**CITY OF SACRAMENTO**  
1231 I Street, Sacramento, CA 95814

**Permit No: 0012240**

**Nature of Work: 10' MSNRY WALL TRELLIS BBQ GAS ELEC + FRONT ARBOR**

**Subject:** CMU Wall at the Mellon Garden, 919 8<sup>th</sup> Ave, Sac CA

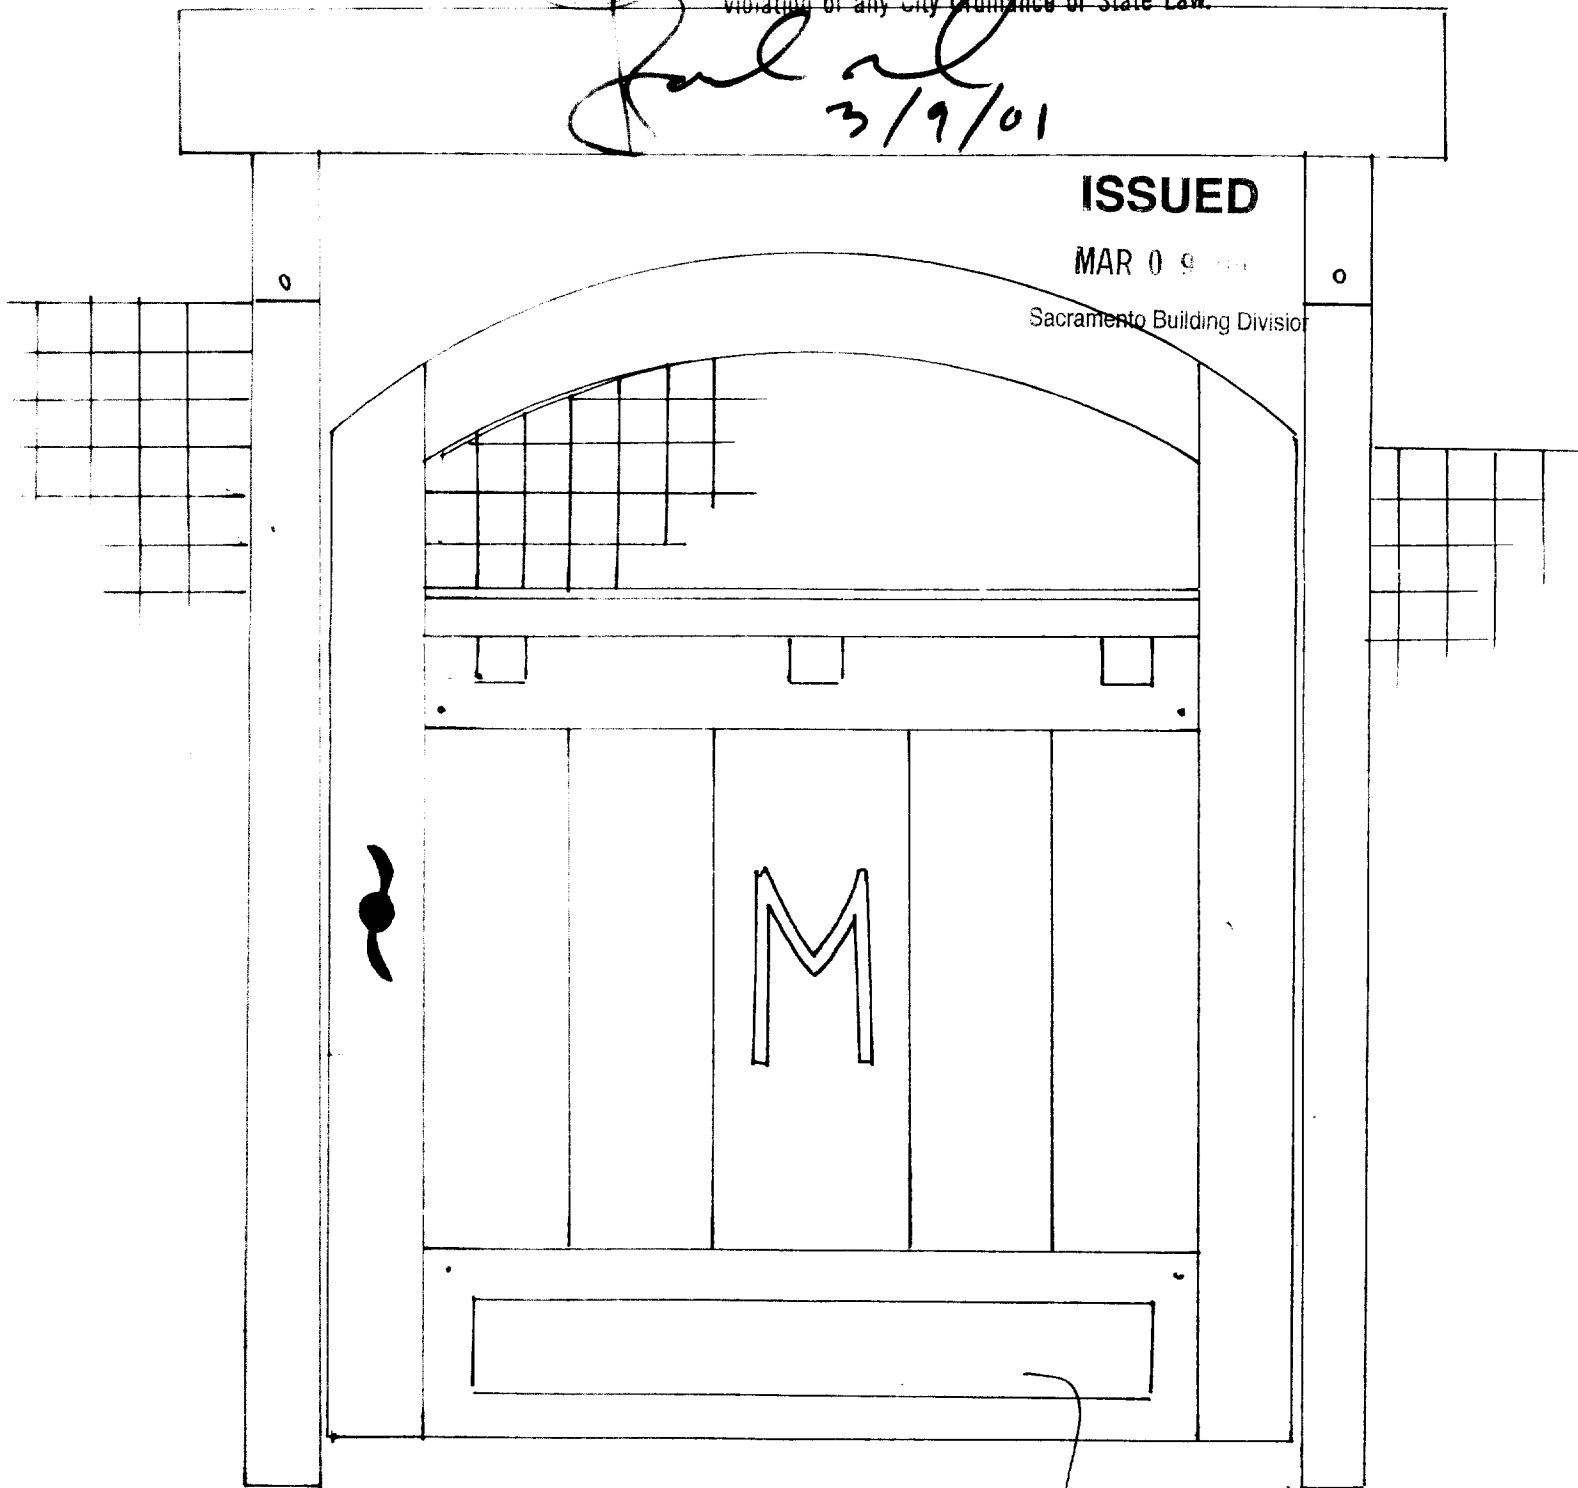
O.K. TO REPLACE AS DESIGN FOR GATE SHOWN ON APPROVED PLANS  
0012240 R  
planter box
